From: Jo Blackwell <Jo.Blackwell@brighton.tas.gov.au>
Sent: Wednesday, 20 December 2023 4:43 PM
To: TPC Enquiry
Subject: Draft Planning Scheme Amendment (RZ 2023/002)
Attachments: Attachment C - Representation and Attachments.pdf; Attachment D - Applicants response to representation.pdf; Attachment B - TasNetworks Response.pdf; Attachment E - TasWater response to representation.pdf; Attachment A- TasWater SPAN.pdf; 203 and 205 Old Beach Road - S40K Report.pdf

5.1 PLANNING SCHEME AMENDMENT FOR 203 and 205 OLD BEACH ROAD,
OLD BEACH – RZ 2023-002

Type of Report	Section 40K of <i>Land Use Planning and Approvals Act 1993</i>
File Reference:	RZ 2023-002
Requested by	JMG Engineers and Planners
Owner/s:	Mark Nolan Lisa Schimanski
Location:	203 Old Beach Road, Old Beach 205 Old Beach Road, Old Beach
Proposal:	Amend the planning scheme map to: A. Rezone the land at 203 and 205 Old Beach Road, Old Beach from Future Urban Zone to General Residential Zone, Low Density Residential Zone, Environmental Management and Open Space Zone B. Amend the Priority Vegetation Overlay from 203 and 205 Old Beach Road, Old Beach, C. Insert the Flood Prone Hazard Overlay over 203 and 205 Old Beach Road, Old Be

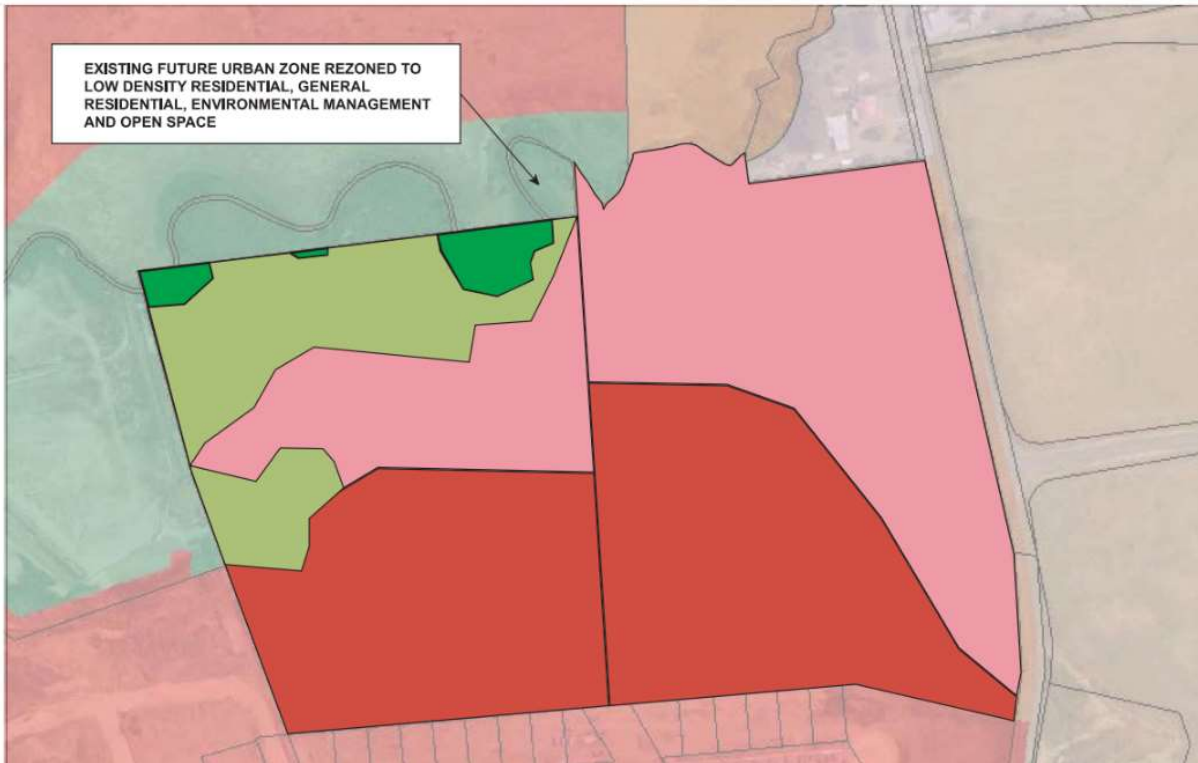
17.	<p>The Flussig Flood Hazard Report (FHR) is the report submitted for SA2022/44 and does not directly address the rezoning application.</p> <p>It is unclear if the flood report means to cover the existing permit or is intended for use with the future multi lot subdivision.</p> <p>Under the flood mapping the proposed SPS is under approximately 2m of water and in the H5 Flood zone</p> <p>Under the flood mapping, the indicative layout for the residential subdivision has lots 12 to 15 significantly within the flood one and within hazard zones H3-H5, whilst the report notes that "any future structures, located in the inundation area, are to be designed to resist flood forces including debris for the given flood</p>	<p>The reports were included to show the impact of the hazards on the site and consequently on the proposed rezoning and overlays.</p> <p>The Flood-Prone Hazard Code applies to any development of land within a flood prone hazard area, whether mapped or identified by council, based on information it has in its possession that the land is subject to risk from flood or has the potential to cause increased risk from flood.</p> <p>Council officers advise that the land affected by flooding would not be considered acceptable to Council as Public Open Space. Additionally, the flood affected land in the H3 to H5 hazard bands should not form part of residential lots. The proposed zoning map shows the flood affected land is to be zoned environmental management.</p>

<p>conditions". This seems like unnecessarily inviting risk when the flood map demonstrates inundation of up to 1.6m</p> <p>The FHR recommends that the indicative layout provides an unimpeded overland flow from the southern boundary of 205 Old Beach Road towards Gage Brook. If this overland flow path is zoned Open Space it could also provide public connection to the Tivoli Green Open Space and prove an area for stormwater treatment</p> <p>There are no calculations in the flood model regarding the impact of future subdivision and how future residential would affect flooding.</p>	<p>The representation was also referred to TasWater for further comment (Attachment E).</p> <p>It is considered that future use and development can be controlled by the applicable zone and code provisions of the planning scheme, together with TasWater's requirements relating to any proposed SPS.</p>
--	--	--

The representor correctly identifies the risks associated with the flood hazard affecting the site. Some of the land identified to be rezoned to the General Residential zone falls within the flood affected land.

The zoning map in the applicant's s37 application shows the area of land identified as H3-H5 as Environmental Management, which will increase the safety and reduce the risk to people and property.
